Queries raised by various vendors through e-mail & during pre-bid meeting of Tender Ref No. :- RGPPL/C&M/CS- 2613/OT-78 dtd. 6th March 2018 and its replies as follows.

AMENDMENT-01 TO TECHNICAL SPECIFICATION (SECTION VI)

REV.	DESCRIPTION	DESIGN	CHKD.	C&I	C	E	APPD.	DATE	PRG NO.	TITLE
1	REVISED FOR TENDER							02.04.18		2X40cum/hr DESALINATION PLANT AT RGPPPL
0.	RELEASED FOR TENDER							02.11.17		P&I DIAGRAM FOR DESALINATION PLANT
										CW-EN-9886-PVM-A-001 (R1)

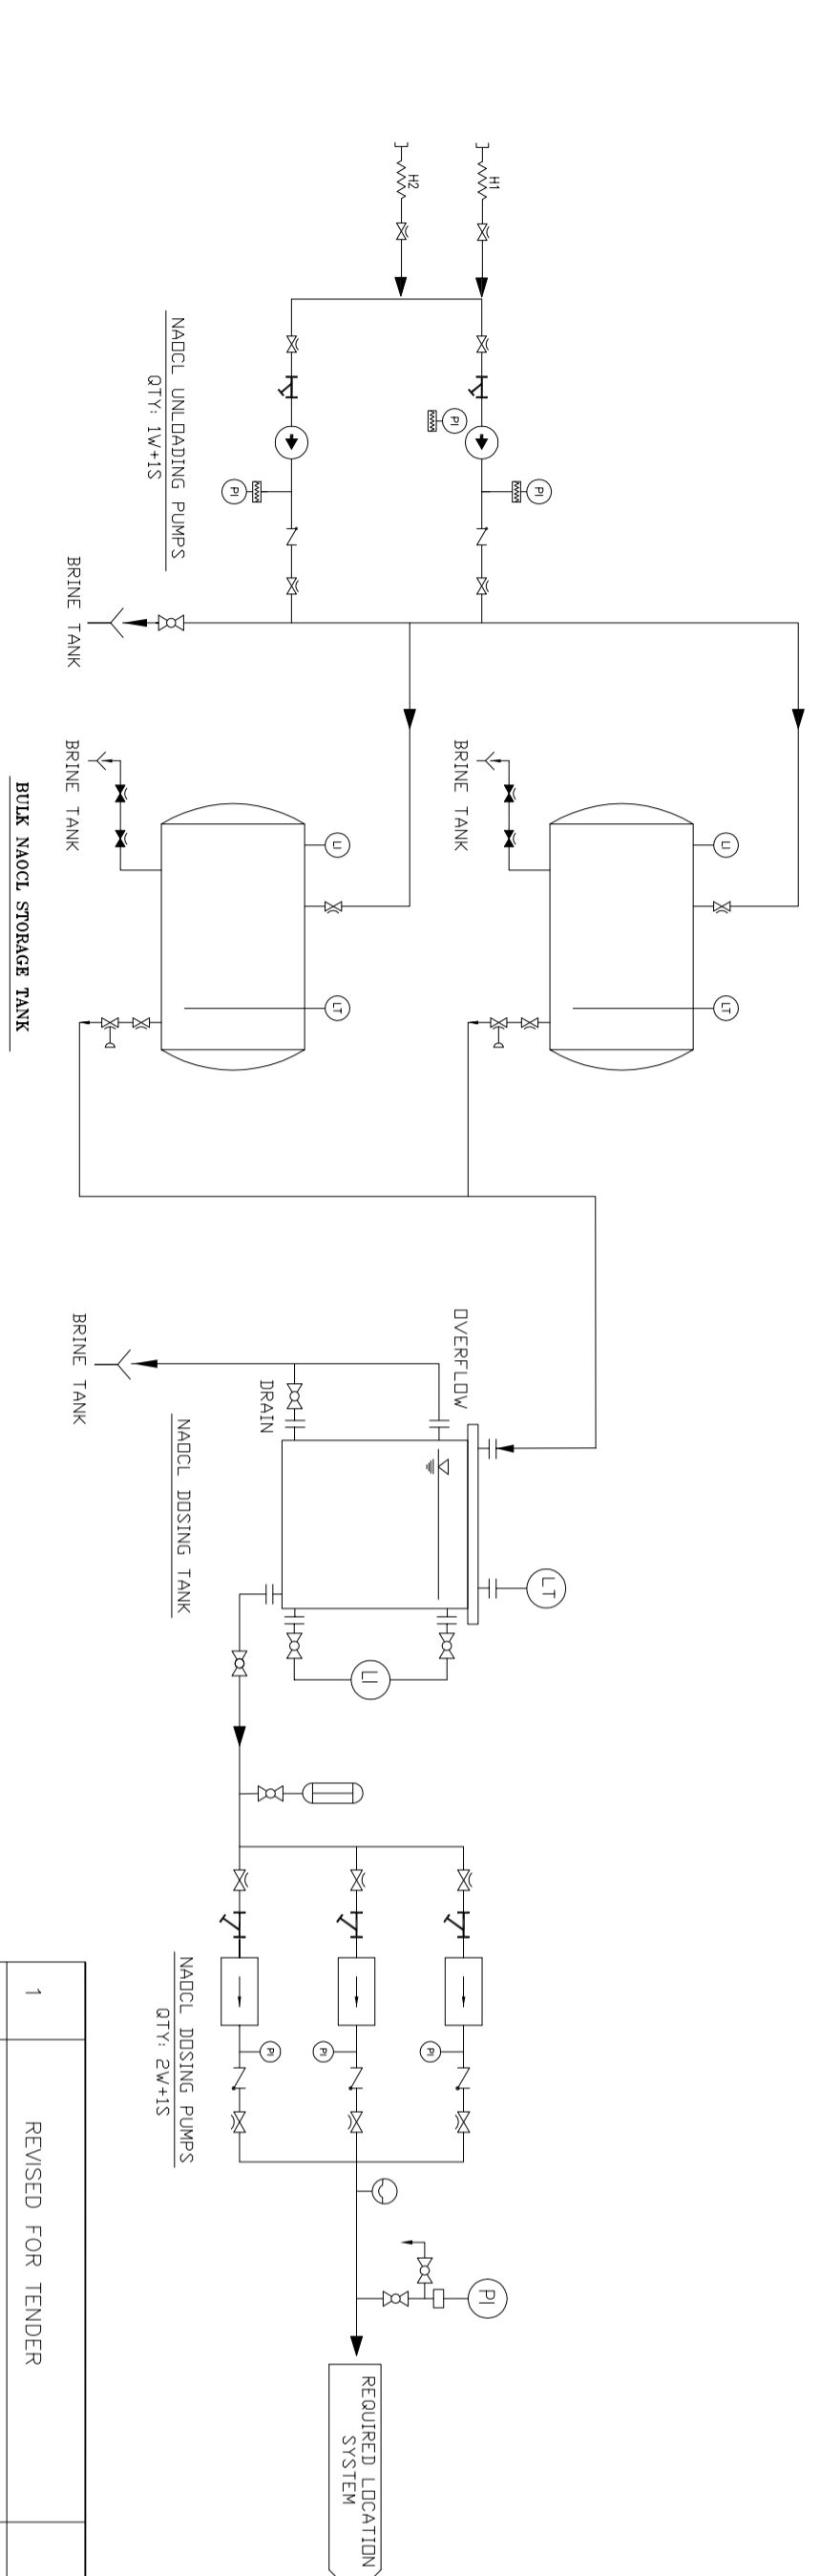
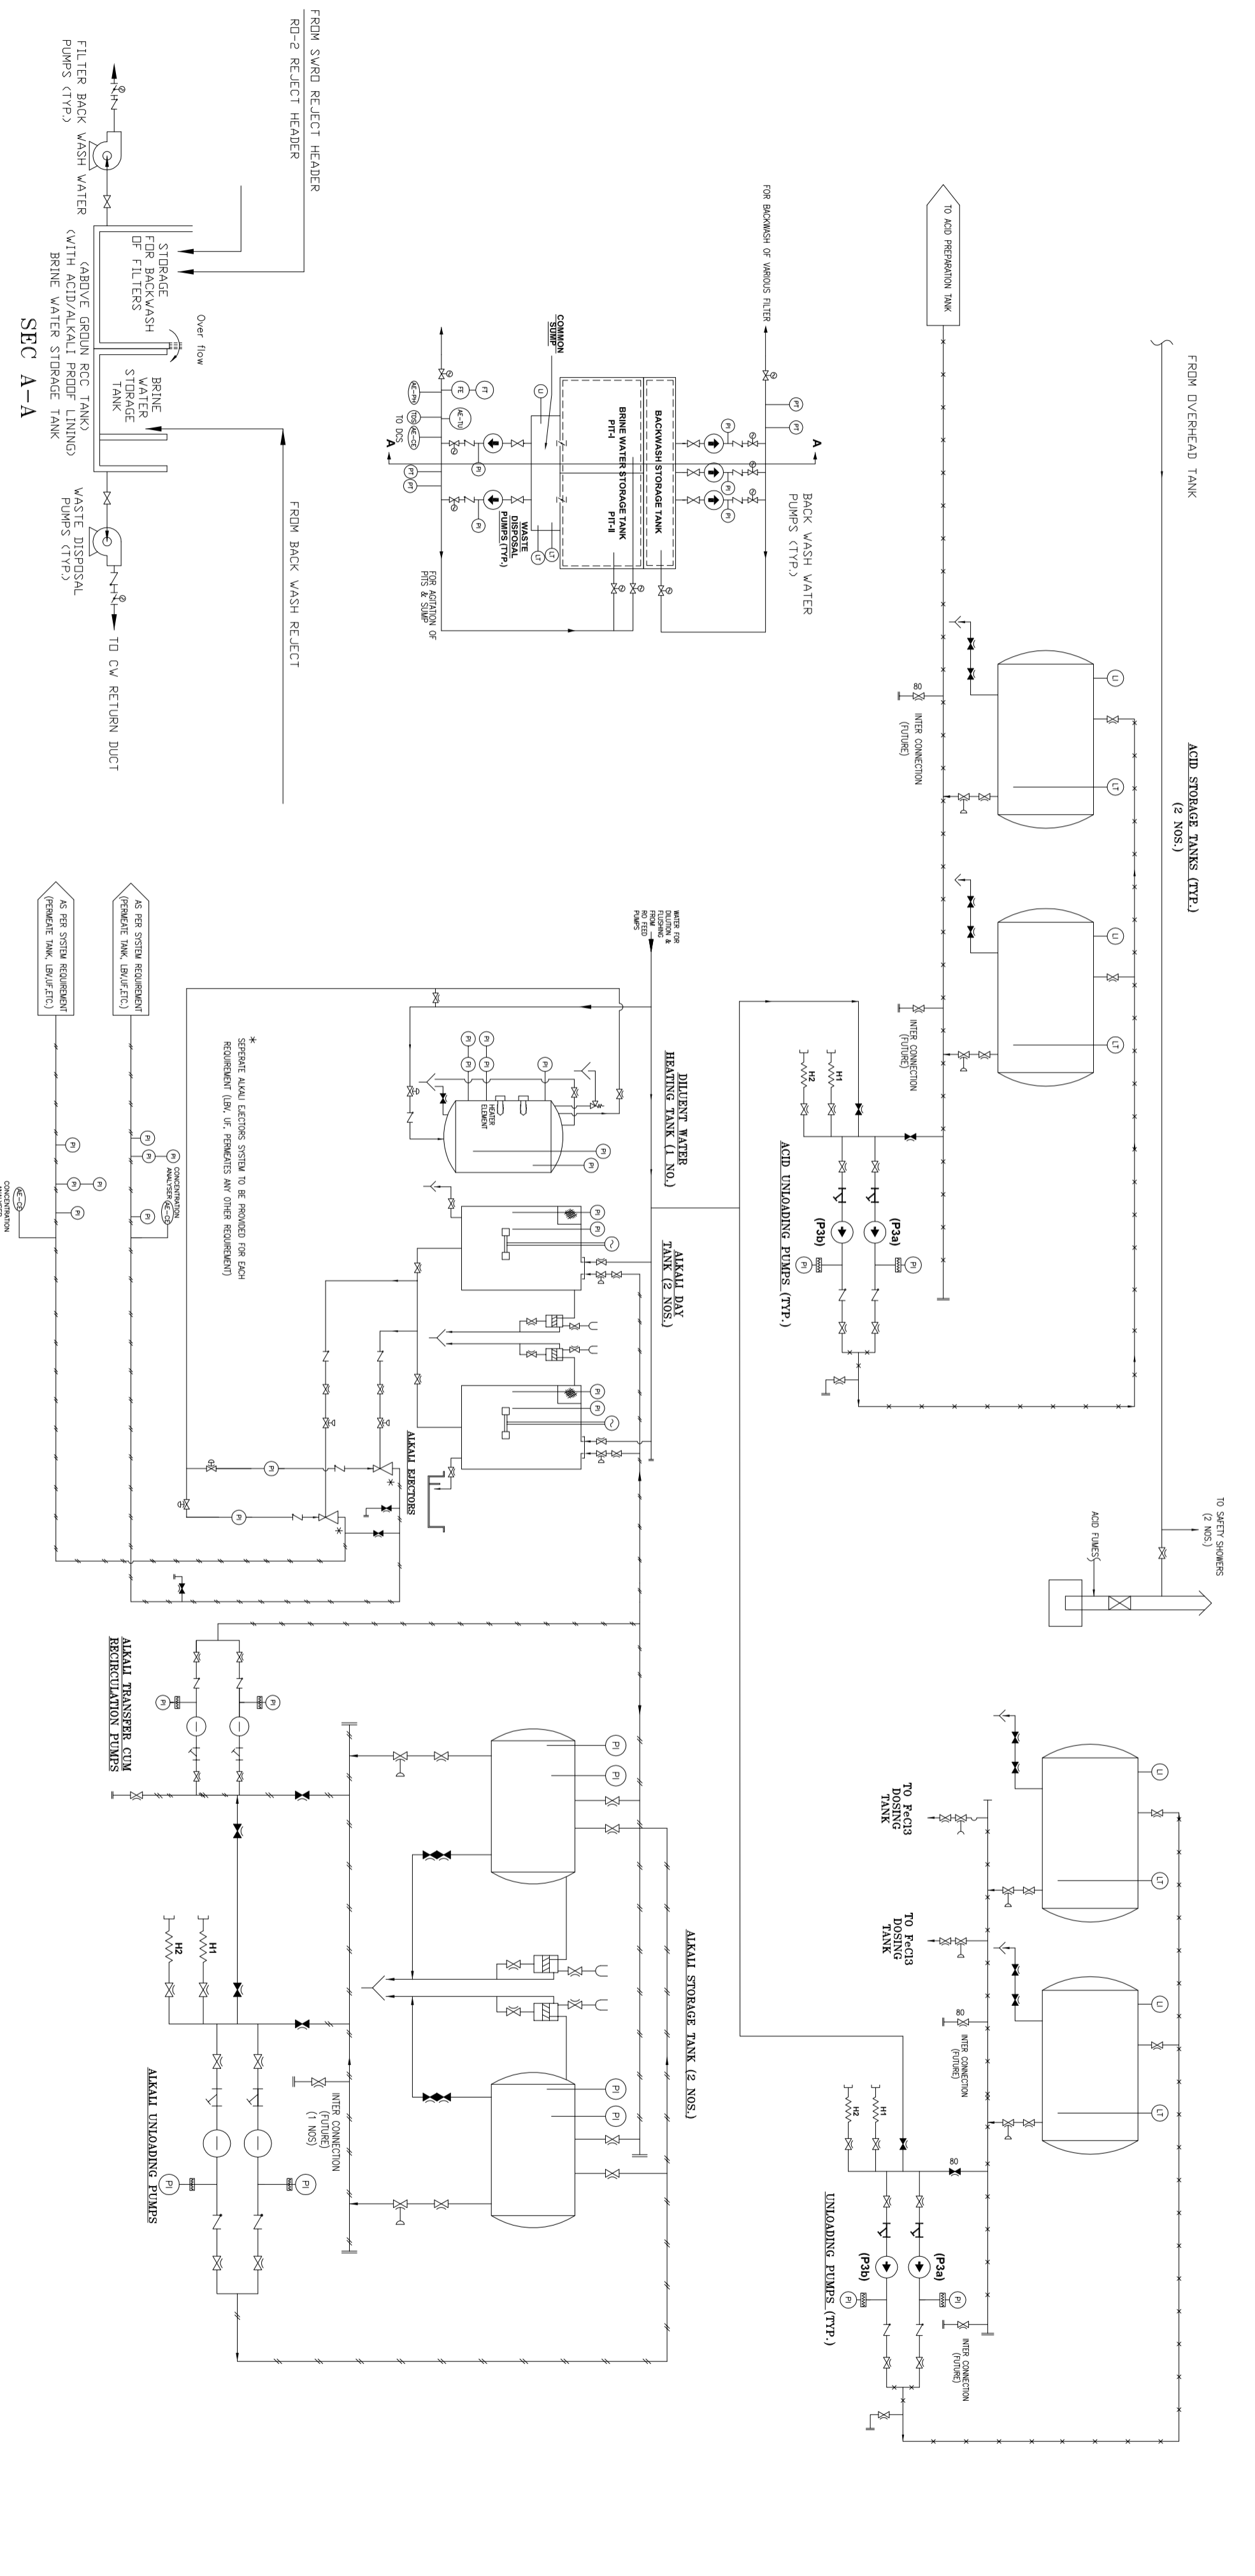
2)	TDS	ppm	Less than 400 ppm considering inlet water temperature upto 30 deg C																															
14	VI / B	IIIA-04 / REVERSE OSMOSIS SYSTEM	12 OF 12	18.02.00	Dosing of acid, alkali and lime shall also be provided to -----one (1) number lime tank of Stainless steel shall be provided with dissolving basket, agitator etc.	Dosing of acid, alkali and lime shall also be provided ----- one (1) number lime tank of Stainless steel / RCC shall be provided with dissolving basket, agitator etc.																												
15	VI / B	IIIA-11 / ANNEXURE-2 (MOC FOR PIPES)	1,2,3 OF 3		ANNEXURE-II	Chapter replaced with chapter ANNEXURE-2(R1)																												
16	VI / E	Tender Drawing	Sheet 7,8,9 OF 9		CW-EN-9886-PVM-A-001 sheet 7 of 9 CW-EN-9886-PVM-A-001 sheet 8 of 9 CW-EN-9886-PVM-A-001 sheet 9 of 9	CW-EN-9886-PVM-A-001(R1) sheet 7 of 9 CW-EN-9886-PVM-A-001(R1) sheet 8 of 9 CW-EN-9886-PVM-A-001(R1) sheet 9 of 9
